Summary of comments received from March 13 open house.

Proposed Illustrative Site Plan

COLLINGWOOD VILLAGE

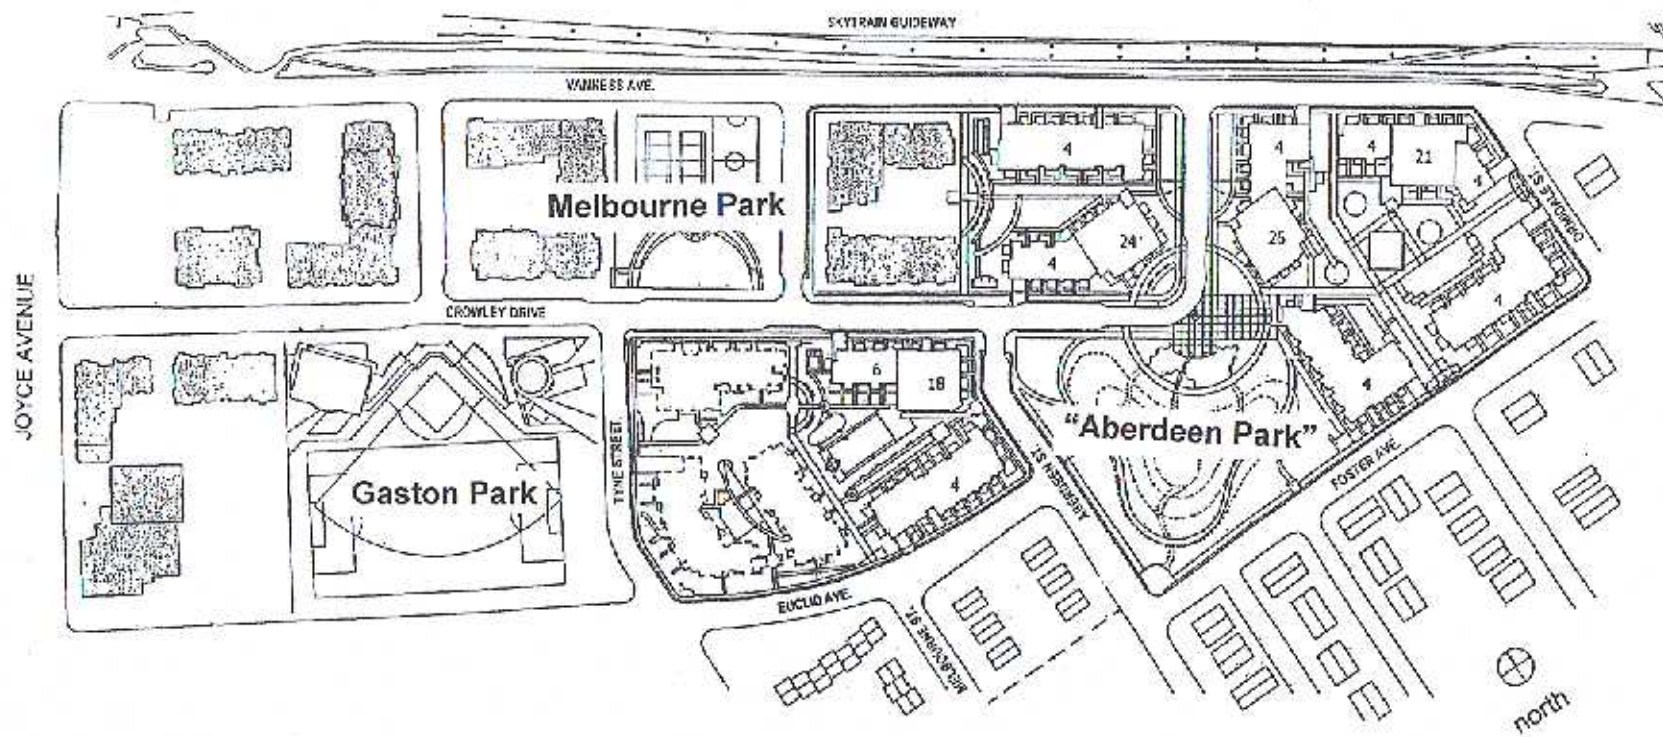
Water park acceptable with simple style of spray jets,
Creation of rolling topography desirable, low mounds at street, 5' knoll, level open lawn ok for informal play/picnic;
Play area encouraged for small kids;
Include seating with view to play area;
Consider community garden in area;
Round corners where paths/plaza meet;
Skateboarders need a place to go to reduce damage elsewhere, consider designated skateboard area;
Concern for skateboard use and damage to park and conflict with other users;
Consider picnic tables and barbeque area;
Provide for ample garbage containers;
Deter cycling on paths or methods to reduce conflict with pedestrians;
Consider donation program for benches;
Encourage evening use (to 10:00 Pm), include lighting for paths but not fields;
Consider dog off-leash area;
Add flower gardens where appropriate for colour and seasonal interest. Variety of trees for seasonal interest;
Open views from small plaza to play area important;

Consider track for radio controlled cars;

Generally positive response to overall design, including size and route of paths, amount of trees, play structures and water play, mounds and lookout plaza.
Passive use by seniors, families and kids desirable.
